Product Change Notification

1. ECR #: 191370
Notification #: 511

- S1SS - S1SS 1MM CABLE ASSEMBLY
- S1SST - 1MM CABLE ASSEMBLY

4. Part #'s Affected

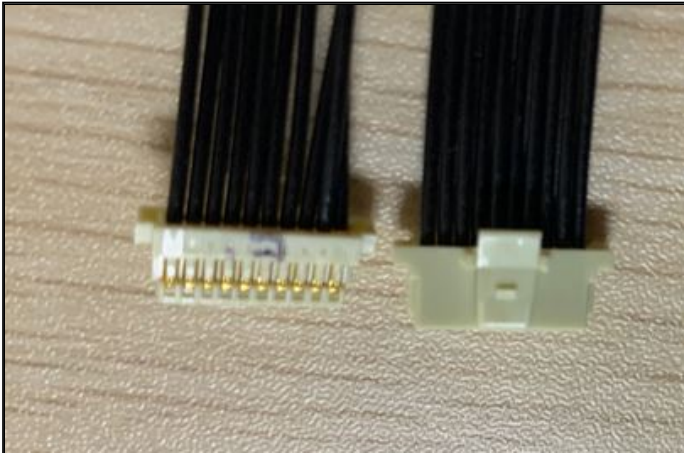
The color of the existing house fades over time which leads to inconsistent color differences. The new color of the housing will not fade and also matches the color of the mating connector (T1XSX).

S1SSX with light green color

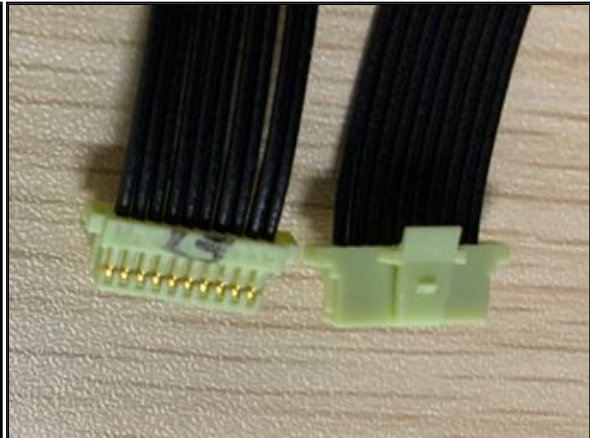
Visual inspection
